PRODUCT/PROCESS CHANGE NOTICE (PCN)

PCN #: **TB1504-01 (R1)** DATE **October 23, 2015**
Product Affected: **Selective Products shipped in Reel**
 (Refer to Attachment II for affected part#)

ATTACHMENT I - PCN #: TB1504-01 (R1)

Figure 1: Additional Label pasted on ESD/Moisture barrier bag and Pizza box

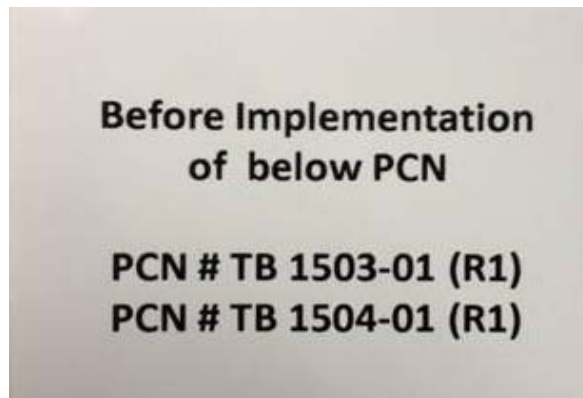
Customers may expect to receive shipments of products in new packing no sooner than 90 days from the date of this PCN notification. Shipments to customers may contain products shipped with either the existing packing or new packing during the transition period. Shipments made in the existing packing after the PCN becomes effective will have an additional label pasted on the ESD/moisture barrier bag and pizza box.
